PROPOSED UPLAND LANDFILL

HYDROGEOLOGICAL REVIEW

BY: DR. GILLES WENDLING, P.ENG.
GW SOLUTIONS

FOR:
CAMPBELL RIVER ENVIRONMENTAL
COMMITTEE (CREC)

FIGURE 3.0C

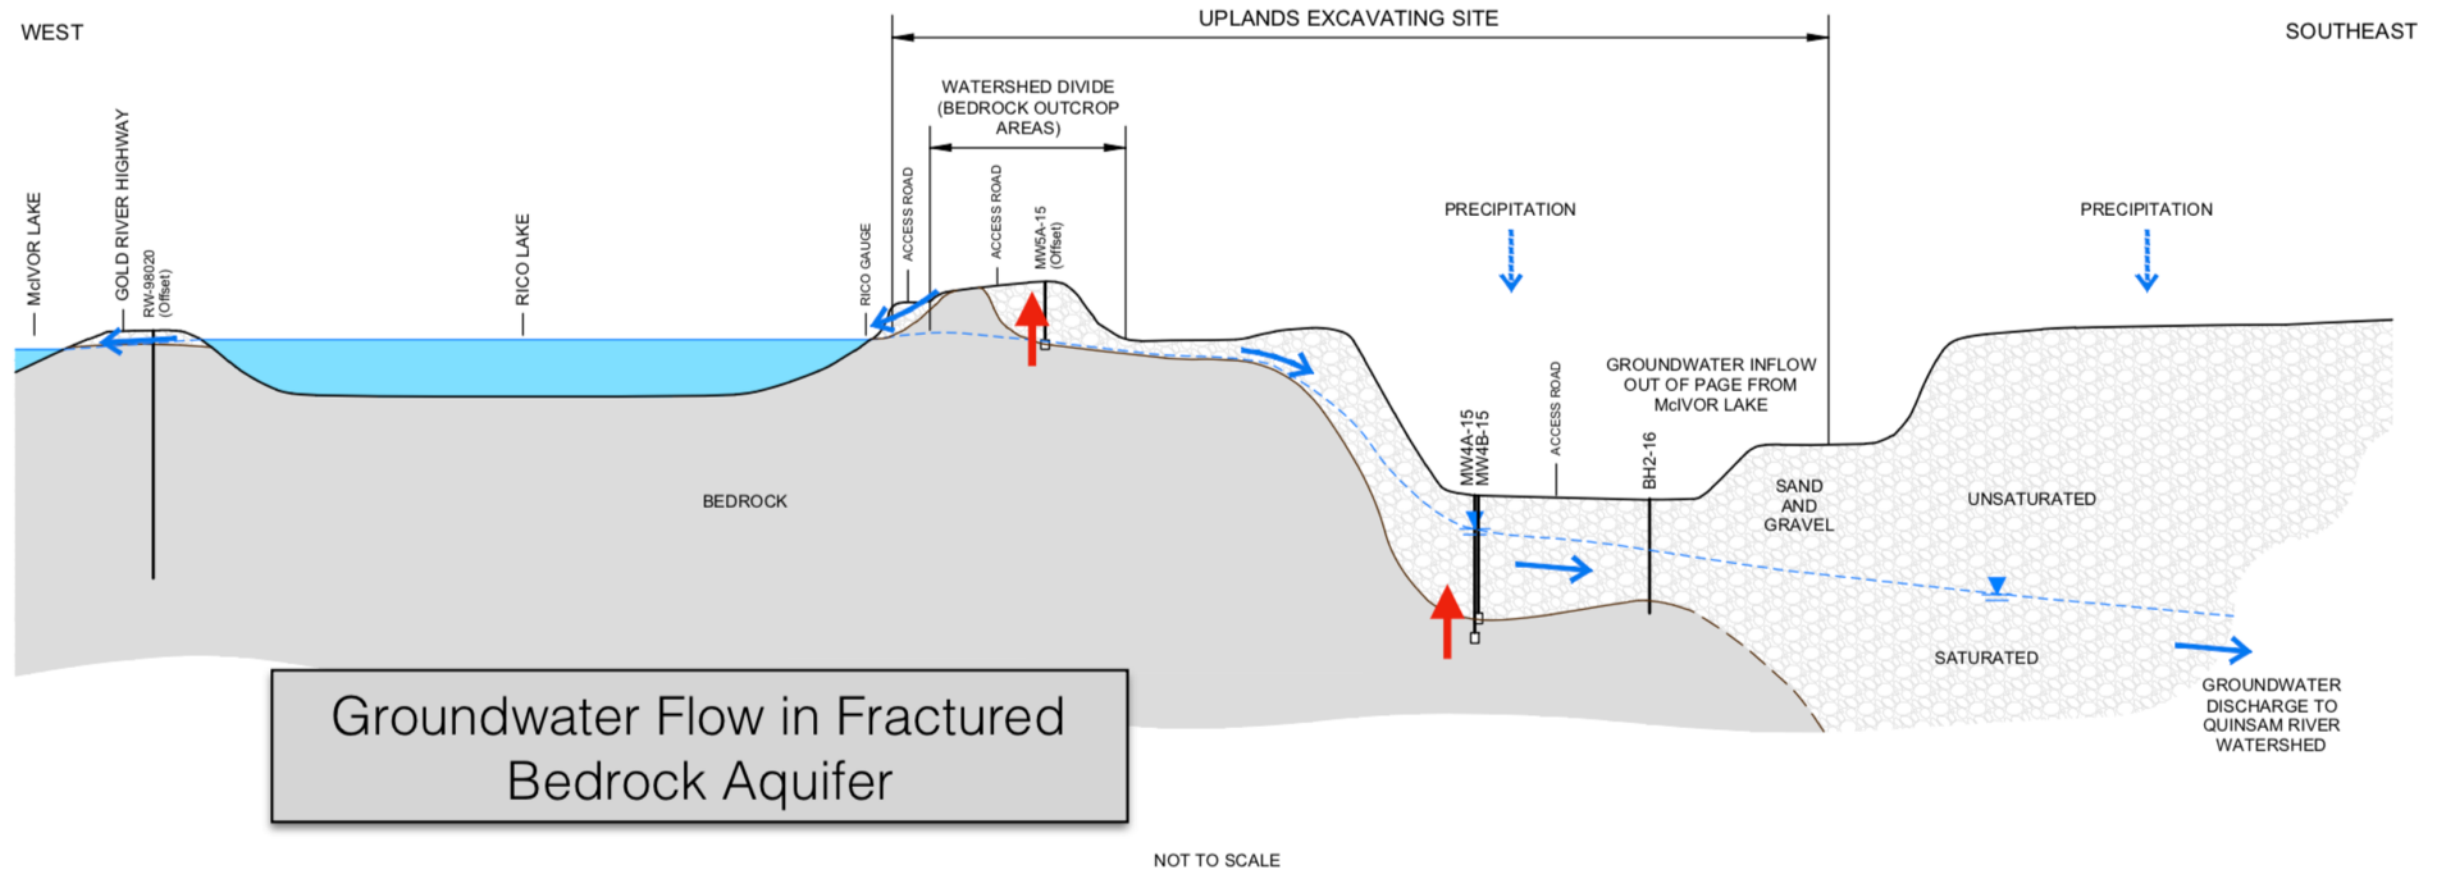
- NOTES:
1. ONSITE TOPOGRAPHY IS BASED ON THE TOPOGRAPHICAL SURVEY CONDUCTED BY McELHANNEY ASSOCIATE LAND SURVEYING LTD., NOVEMBER 21, 2016.
 2. OFFSITE TOPOGRAPHY HAS BEEN ESTIMATED USING ESRI TOPOGRAPHIC BASEMAP, ACCESSED 2017; BRITISH COLUMBIA MINISTRY OF ENVIRONMENT, WATER PROTECTION AND SUSTAINABILITY BRANCH, SEPTEMBER 11, 2014.
 3. RICO LAKE IS APPROXIMATELY 12 M DEEP (LAKE BOTTOM IS AT 168 mAMSL) - MEASURED BY CAMPBELL RIVER ENVIRONMENTAL COMMITTEE.
 4. ALL LOCATIONS ARE APPROXIMATE AND MEANT TO DEMONSTRATE CONCEPTUAL FLOW DIRECTION.

FIGURE 7.1A

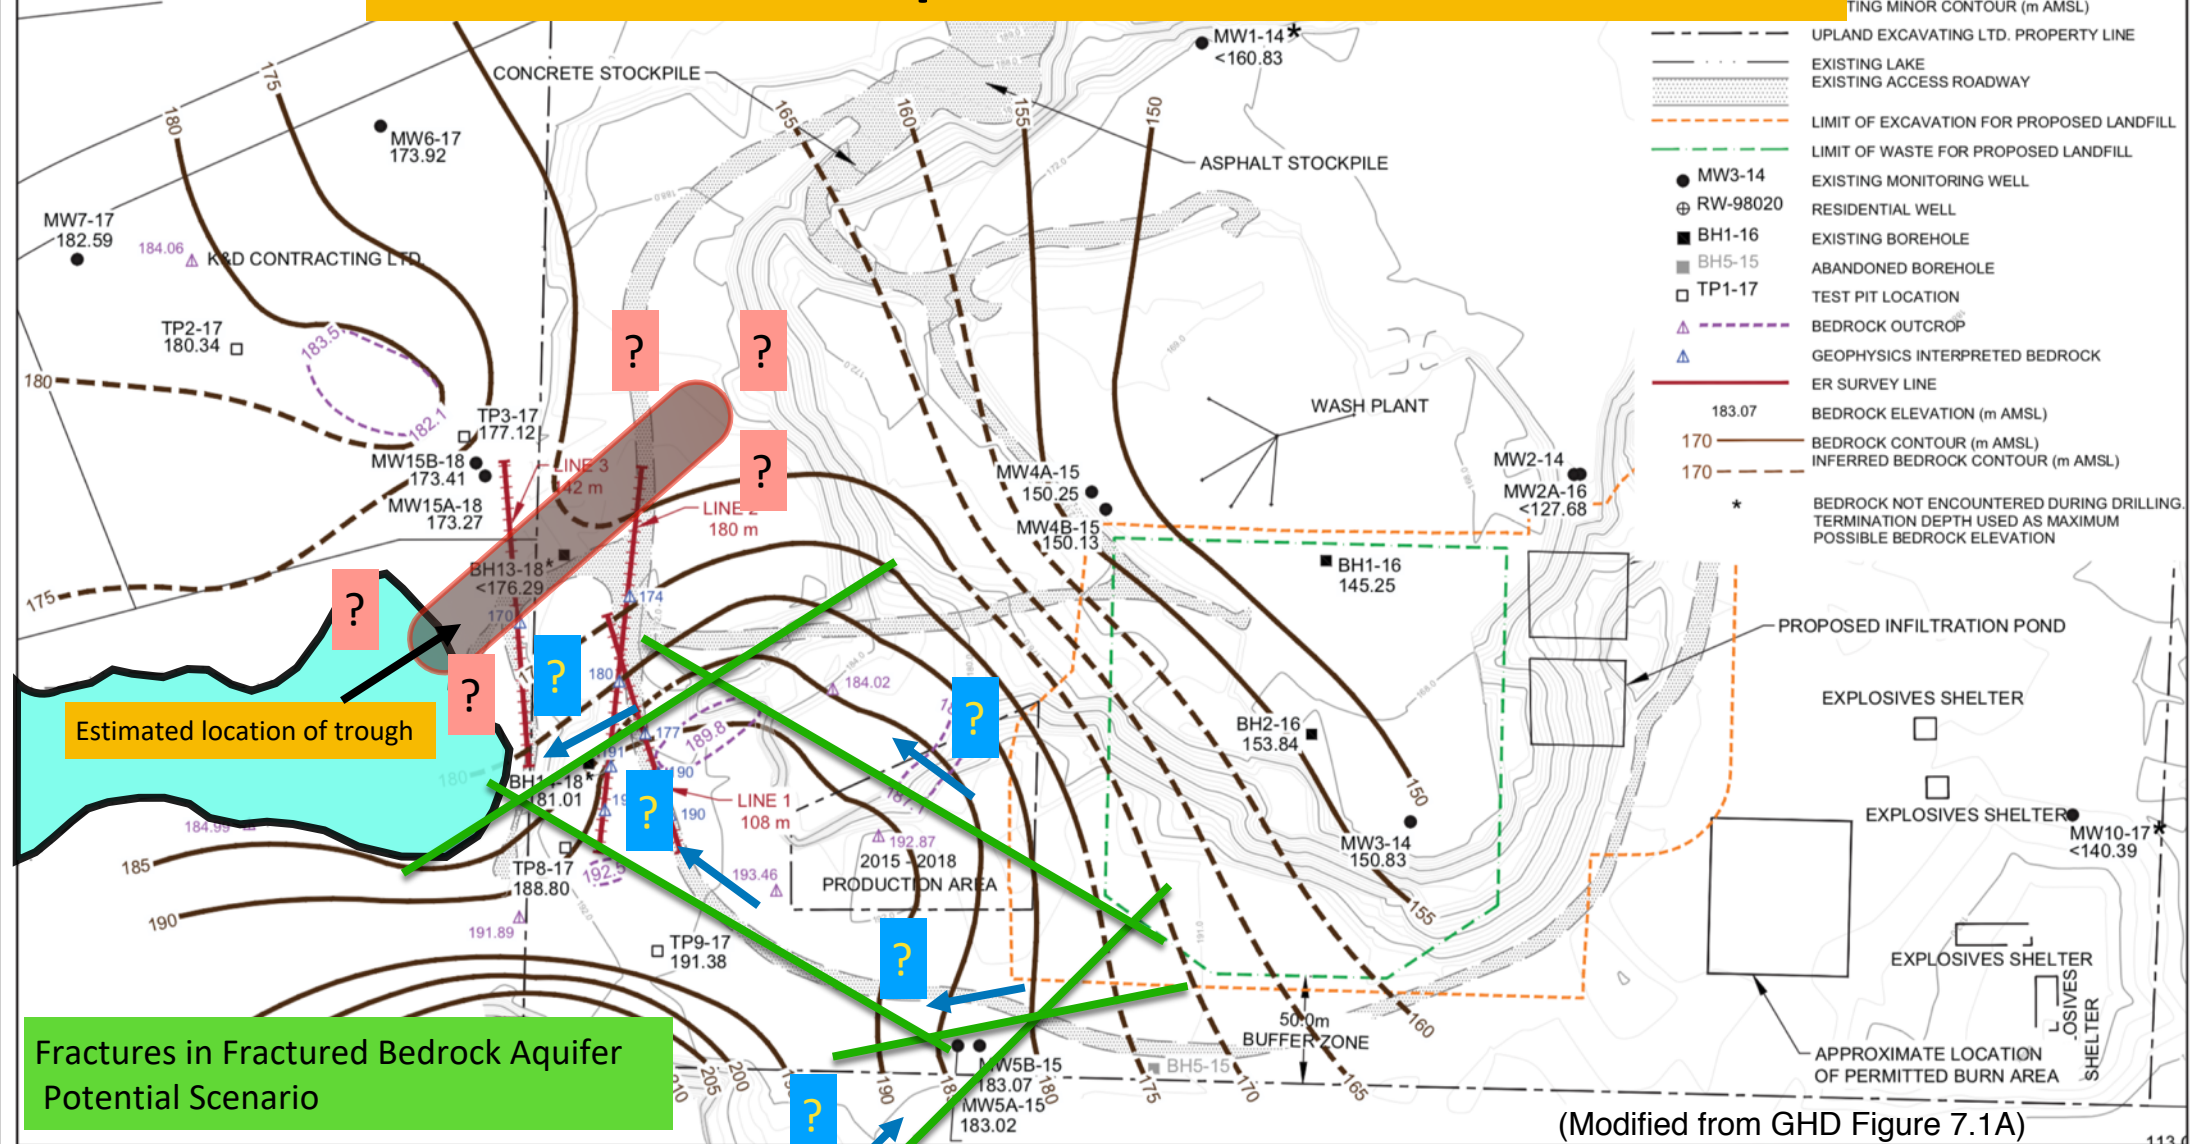
Flow in Bedrock Aquifer still not Characterized

(Modified from GHD Figure 2.11)

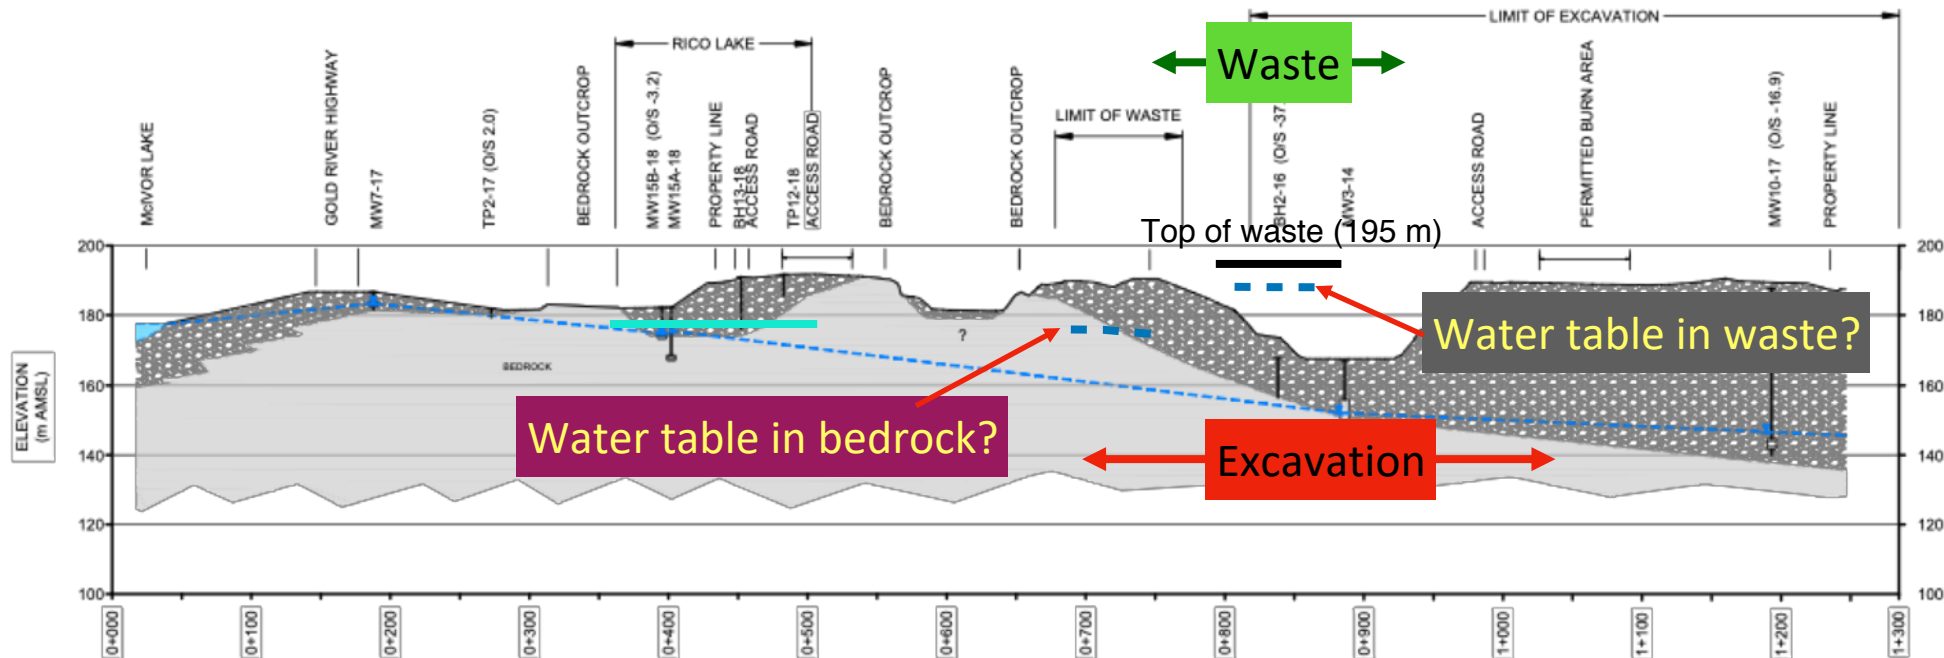
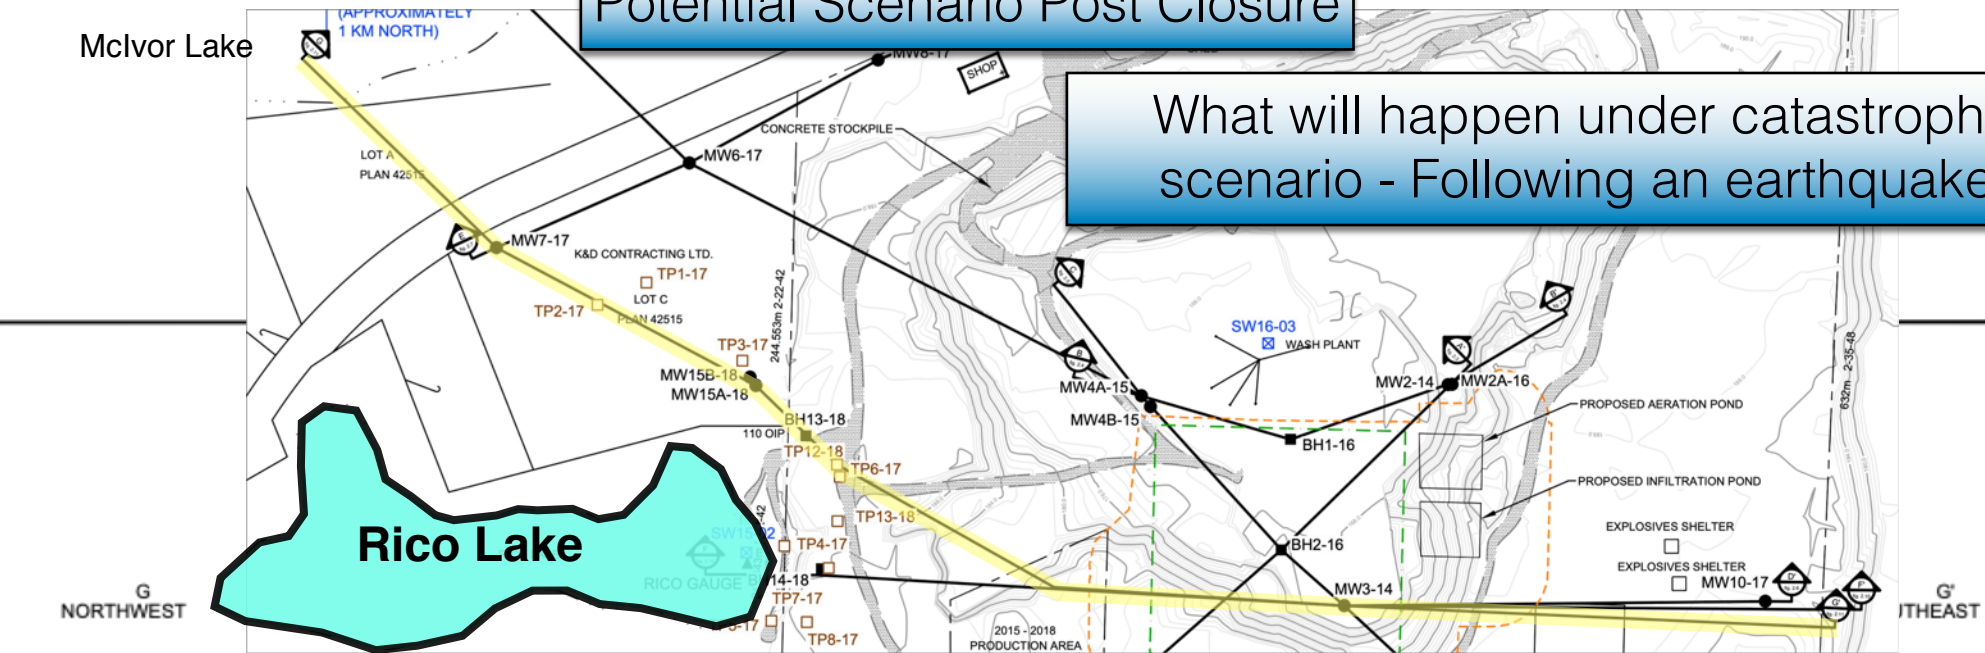
Potential Scenario Post Closure

What will happen under catastrophic scenario - Following an earthquake?
